MILITARY SPECIFICATION

MAGNETIC DISK, DATA STORAGE: 10526600

This amendment forms a part of specification MIL-M-60183(MU), dated 18 March 1965.

FIGURE 1

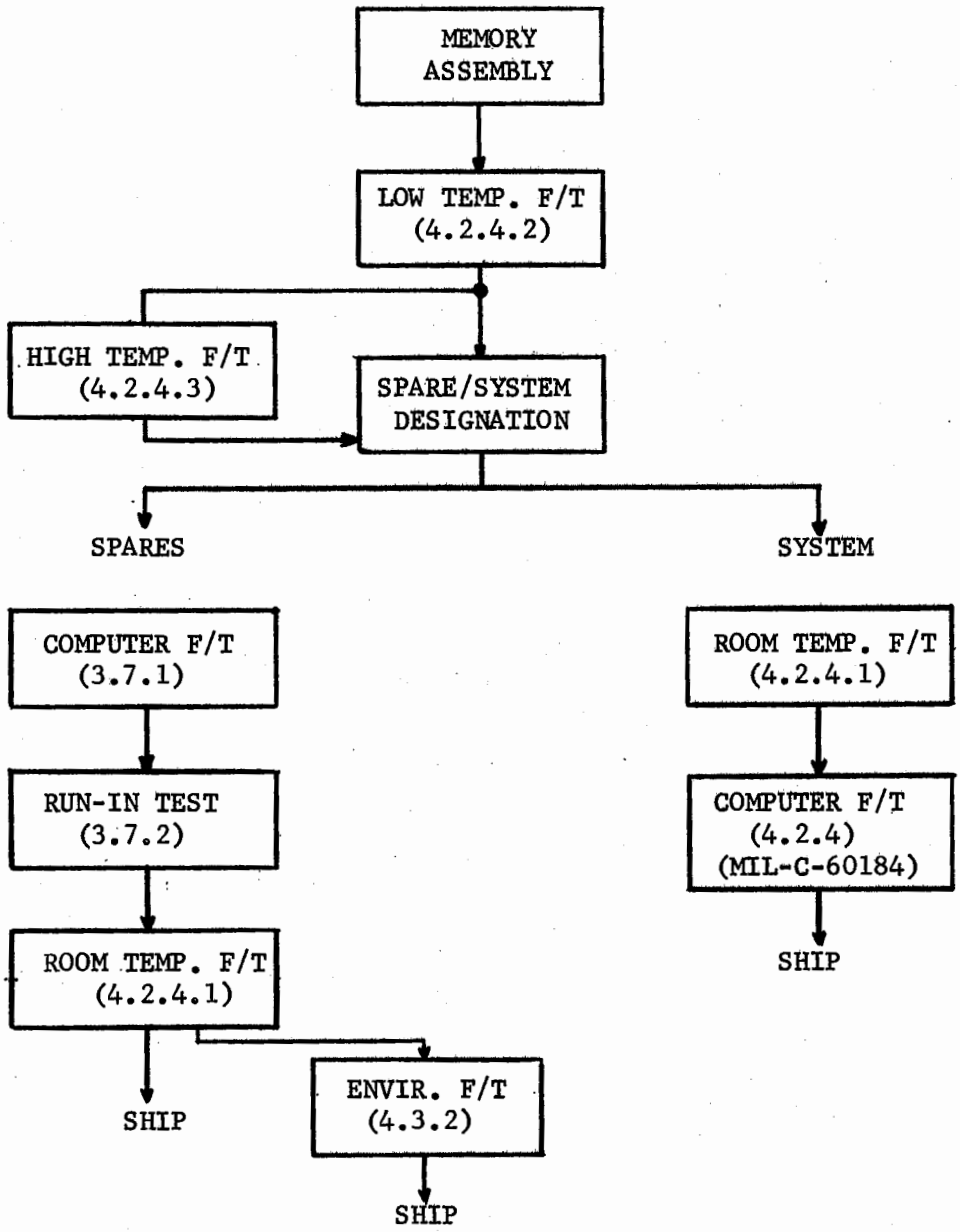
Add new paragraph as follows:

"4.5.2.20 Memory run-in.- Memories shall be subjected to the test program, as shown in Figure I, to determine compliance with the requirements of Paragraph 3.6."
